E. R. Squibb & Sons, Inc.

This is in response to your letter of February 18, 1982 in which you requested additional information with respect to Squibb's Radiological Contingency Plan. Each of your comments have been addressed in the enclosure. Also included are additional or replacement pages for the required information.

Response to Comments on Squibb's Radiological Contingency Plan

FIGURE 1. Portion of Middlesex County, New Jersey, showing location of the E. R. Squibb and Sons facility.

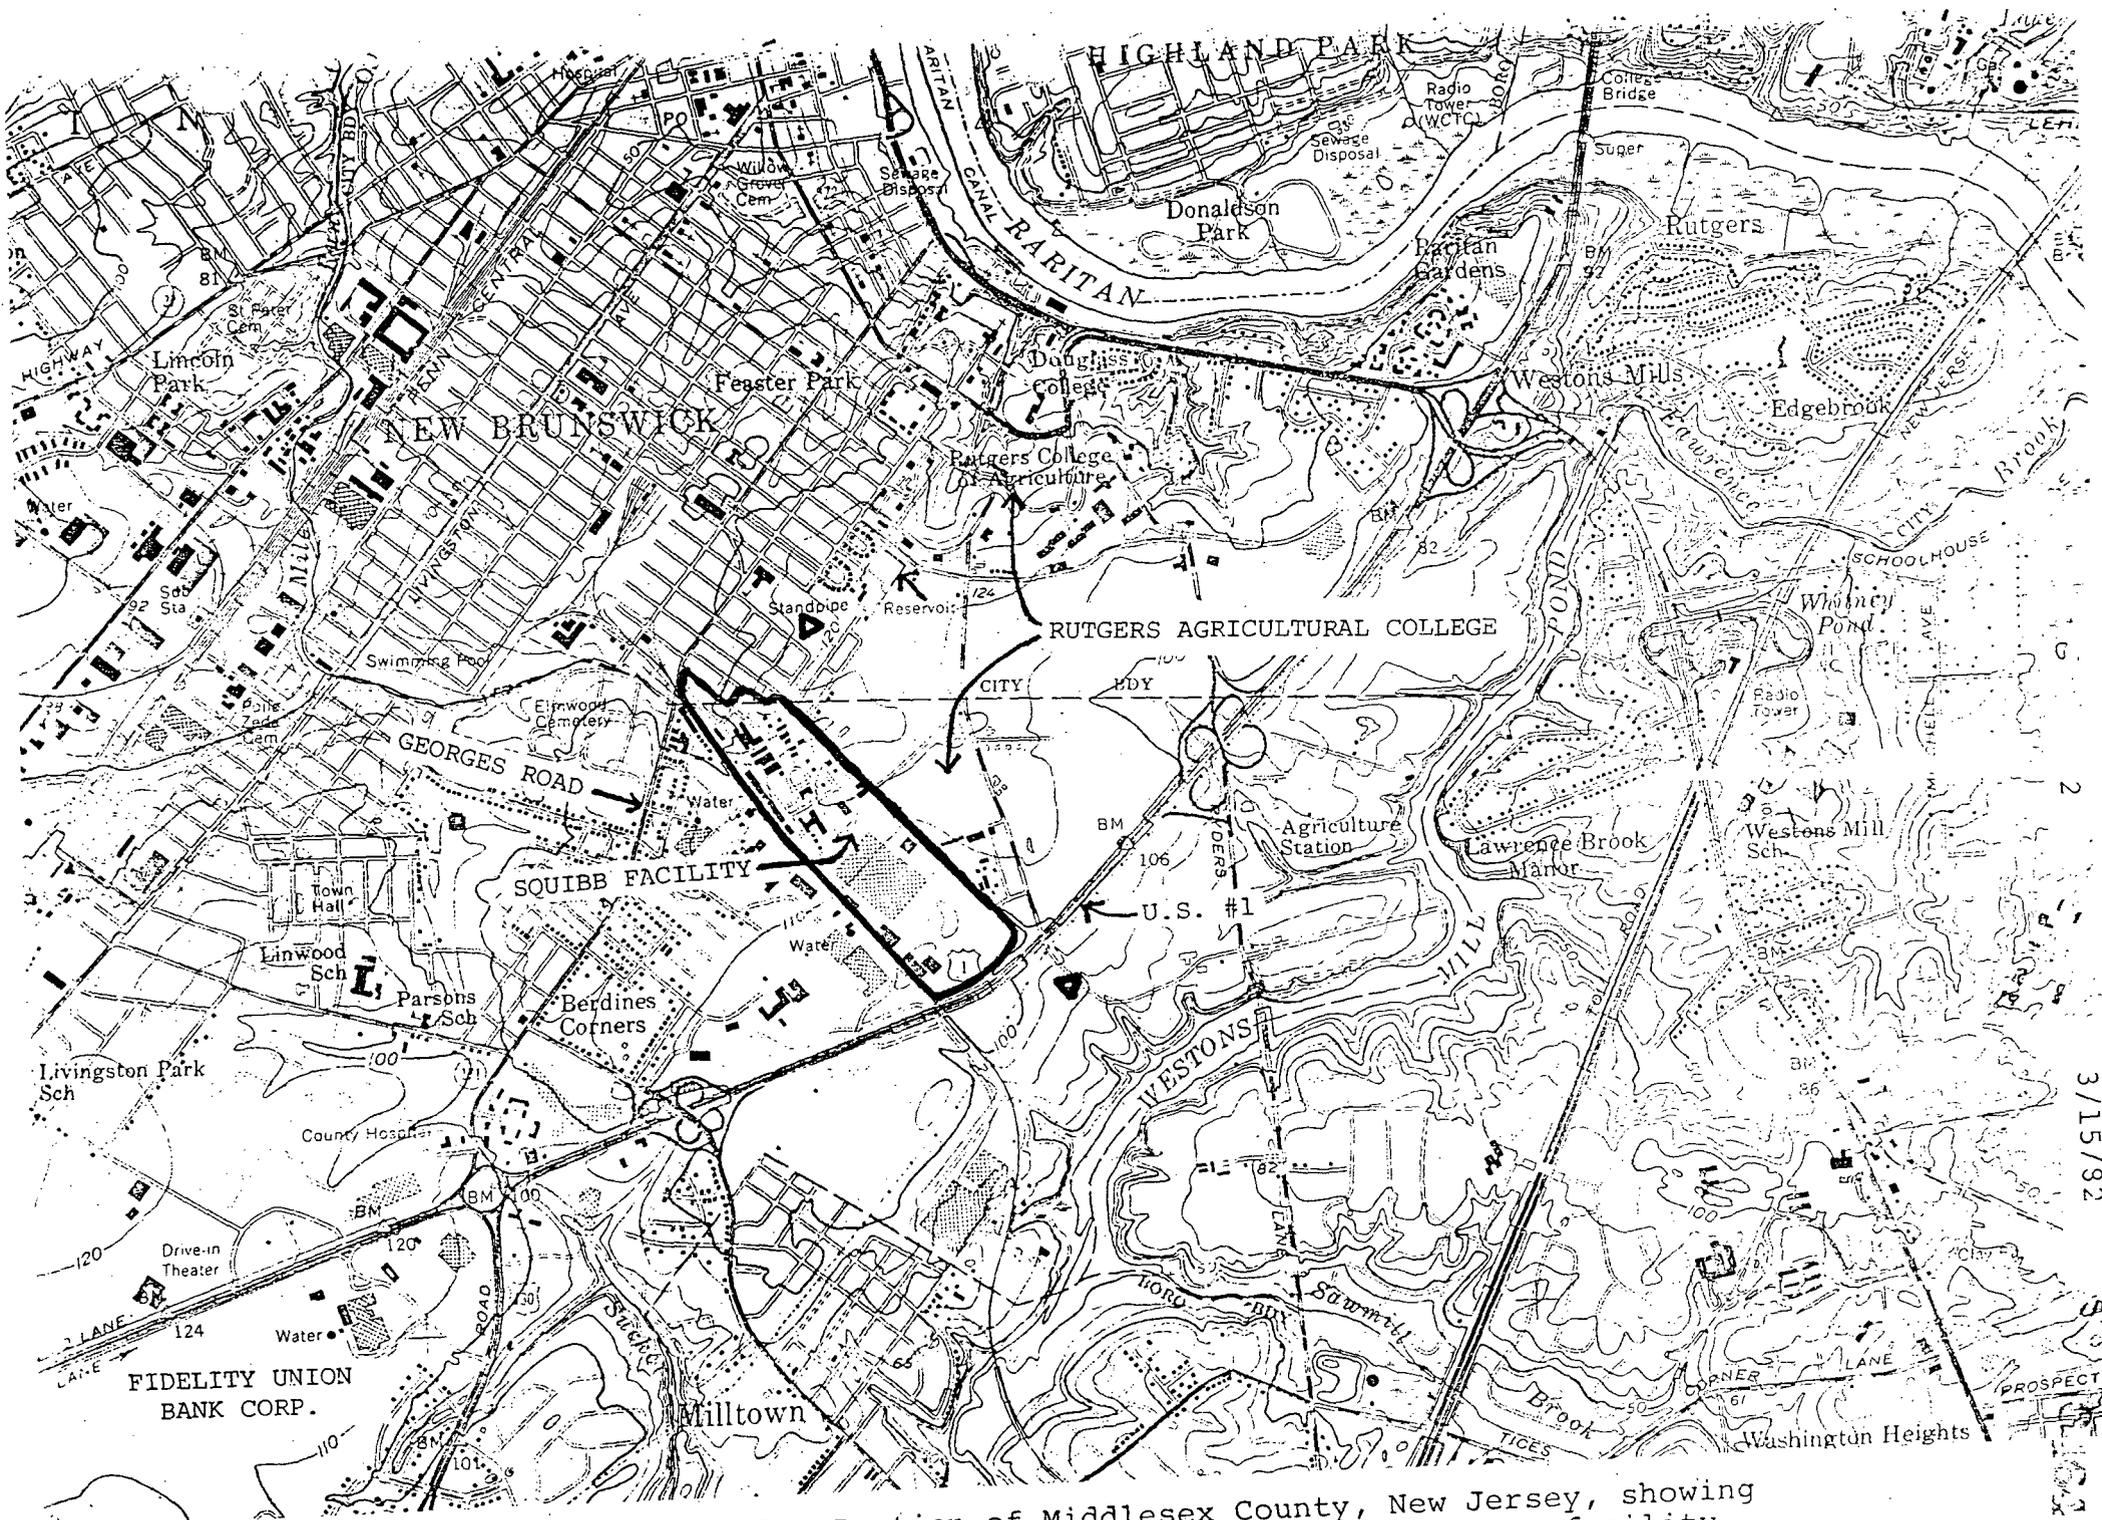
Figure 1., the topographical map which is considered of poor quality has been replaced with one more readable. Also included as part of the site plan is an additional map (Fig. 3a) which depicts the locations of population centers near the site, such as university dormitories or classrooms on the agriculture college.

The Figure 1 replacement and the Figure 3A addition are enclosed.
